SUBJECT: DONALD C. COOK NUCLEAR PLANT, UNITS 1 AND 2 - STAFF ASSESSMENT OF INFORMATION PROVIDED PURSUANT TO TITLE 10 OF THE *CODE OF FEDERAL REGULATIONS* PART 50, SECTION 50.54(f), SEISMIC HAZARD REEVALUATIONS FOR RECOMMENDATION 2.1 OF THE NEAR-TERM TASK FORCE REVIEW OF INSIGHTS FROM THE FUKUSHIMA DAI-ICHI ACCIDENT (TAC NOS. MF3873 AND MF3874)

STAFF ASSESSMENT BY THE OFFICE OF NUCLEAR REACTOR REGULATION

RELATED TO SEISMIC HAZARD AND SCREENING REPORT

DONALD C. COOK NUCLEAR PLANT, UNITS. 1 AND 2

Figure 3.3-1 Plot Comparing the Staff's and the License's Median Amplification Functions and Uncertainties.

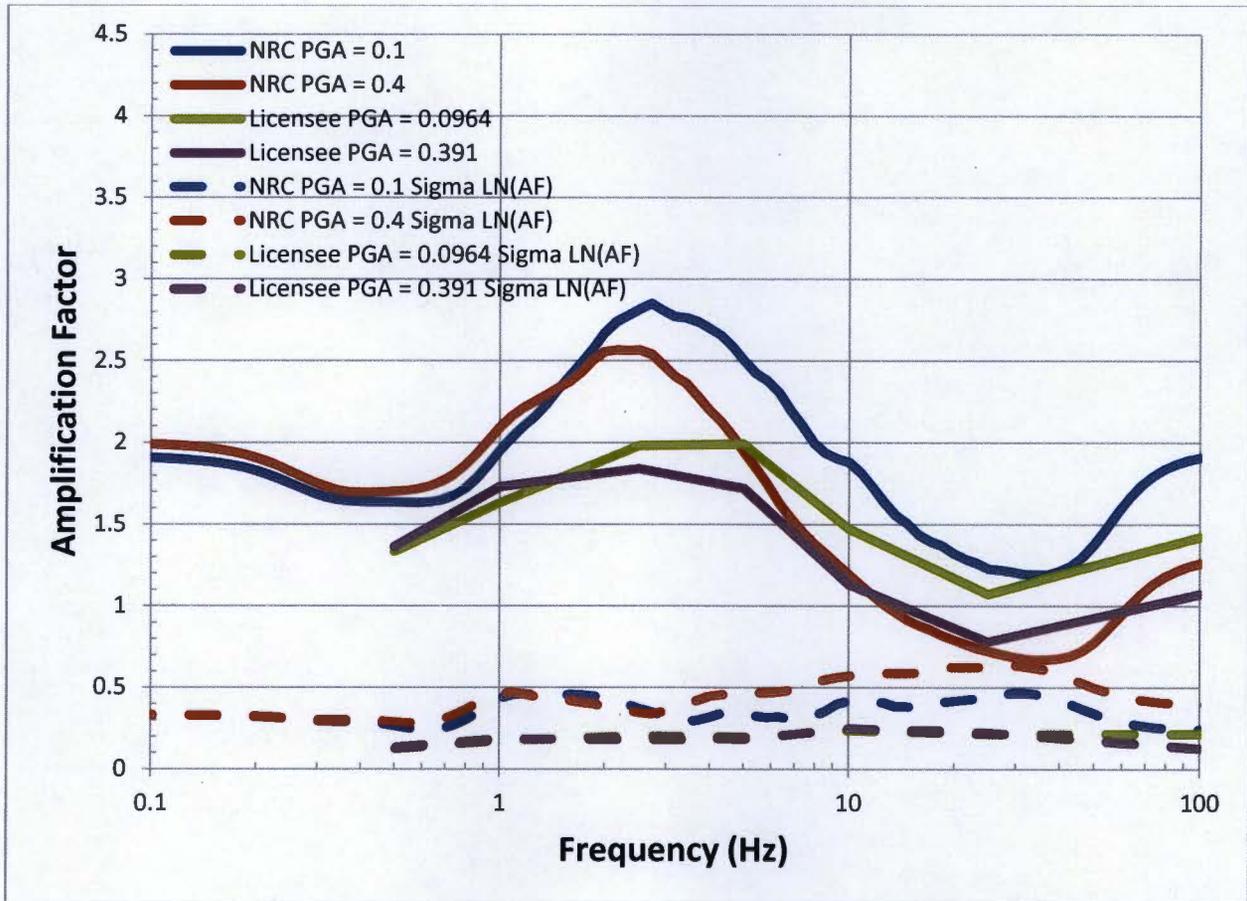
Figure 3.3-2 of this assessment shows a comparison of the staff's and licensee's median site amplification function and uncertainties (± 1 standard deviation) for two of the eleven input loading levels. Peaks in amplification functions occur between 3 Hz and 9 Hz in both staff and licensee curves. Differences in the amplification functions developed by the staff and licensee are due to the licensee's use of six profiles, as described above, with three of the six profiles having reference rock directly beneath the soil layers.

The licensee's approach to modeling the subsurface rock properties and their uncertainty results in lower site amplification factors than those produced by the staff, particularly at high frequencies. As shown in Figure 3.3-3 of this assessment, these differences in site response analysis have a relatively minor impact on the control point seismic hazard curves and the resulting GMRS, discussed below. Appendix B of the SPID provides guidance for performing site response analyses, including capturing the uncertainty for sites with less subsurface data; however, the guidance is neither entirely prescriptive nor comprehensive. As such, various approaches in performing site response analyses, including the modeling of uncertainty, are acceptable for this application.

Figure 3.4-1 Comparison of the Staff's GMRS with Licensee's GMRS and the DC Cook Unit Nos. 1 and 2 SSE

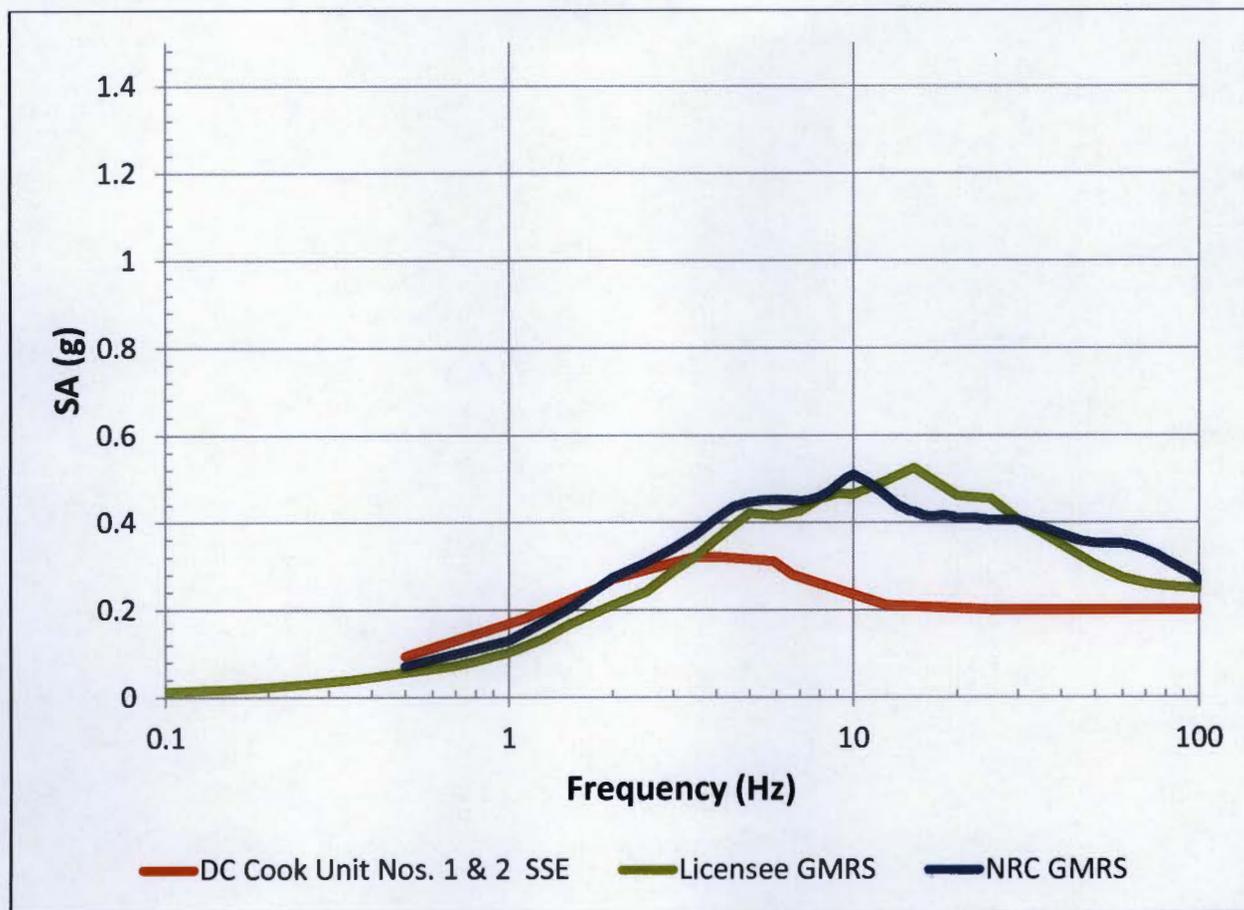
The staff independently calculated the 10^{-4} and 10^{-5} UHRS using the results of its confirmatory PSHA and site response analysis, as described in Sections 3.2 and 3.3 of this staff assessment, respectively. Figure 3.4-1 of this assessment shows a comparison of the GMRS determined by the licensee to that determined by the staff.

As shown in Figure 3.4-1 below, the licensee's GMRS shape is generally similar to that calculated by the staff with minor differences in the location and shape of spectral peaks in GMRS. These differences in GMRS are small and are the result of differences in the site response analyses performed by the licensee and staff discussed in Section 3.3 above. The staff concludes that these differences are acceptable for this application because the licensee followed the guidance provided in the SPID with respect to both the PSHA and site response analysis for the D.C. Cook site. The exception to this is the absence of the sand layer in the licensee's site response analysis, which the licensee has committed to including for future risk evaluation activities (Gebbie, 2014). Given that the sand layer was accounted for in the staff's site response confirmatory analysis and the results obtained were consistent to those obtained by the licensee, the staff does not expect any major changes between the hazard curves submitted for this application and the recalculated hazard curves expected to be used for future risk evaluations.

The staff confirms that the licensee used the present-day guidance and methodology outlined in RG 1.208 and the SPID to calculate the horizontal GMRS, as requested in the 50.54(f) letter. The staff performed both a PSHA and site response confirmatory analysis and achieved results consistent with the licensee's horizontal GMRS. As such, the staff concludes that the GMRS determined by the licensee adequately characterizes the reevaluated hazard for the D.C. Cook

site. Therefore, the GMRS with the sand layer accounted for, is suitable for use in subsequent evaluations and confirmations, as needed, for the response to the 50.54(f) letter.
